SOLICITATION ADDENDUM NO. 4

ITB 20-0034

Security Upgrades: Phase 1 Classroom Walls General Contractor

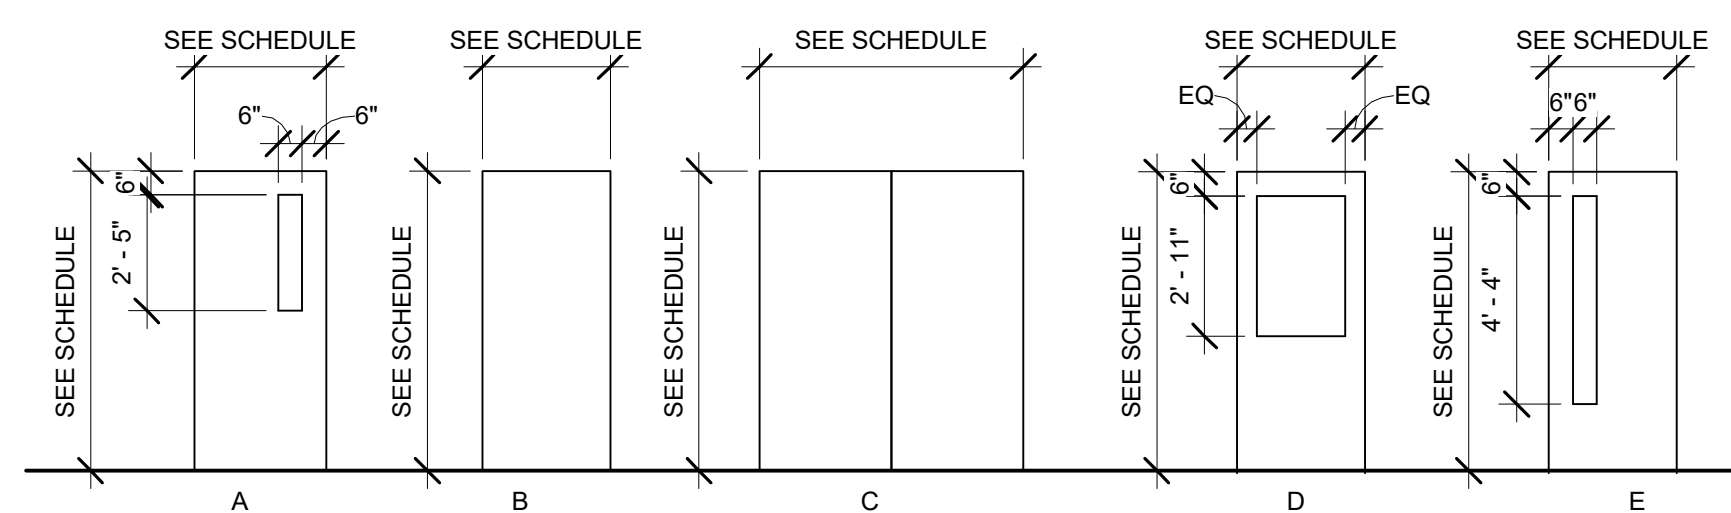
- DA-1 Sheet WTV.A2, Door Schedule - WTV1;
CHANGE Doors M103, M104, and M105 per attached updated drawing with Revision 1. Existing door glass, if present, is to remain as-is.
- DA-2 Sheet WTV.A2, Door Schedule - WTV1;
CHANGE Door M109 per attached updated drawing with Revision 1. Existing door to receive new threshold only per scheduled detail.

ANSWER: Only the threshold is replaced, please see the updated door schedule.
